SCHEMATICS FOR C-64, C-16, PLUS 4

These computers have been affected by an Engineering Change Order that adds 4 diodes to the serial port. These protection diodes are not required as field upgrades. They are 1N914s and were added as a circuit improvement.

PLUS 4 SCHEMATIC

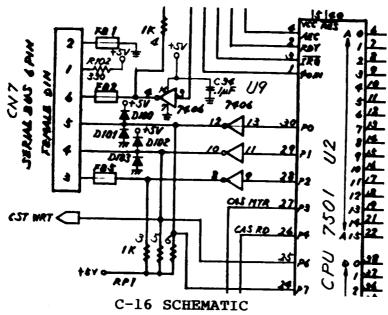
The Schematic and PCB Layout for the C-64 in the Service Manual (Pages 28 and 32) include these diodes. However, the C-16 and Plus 4 Service Manuals were completed before the changes were made. The Schematic corrections are shown below:
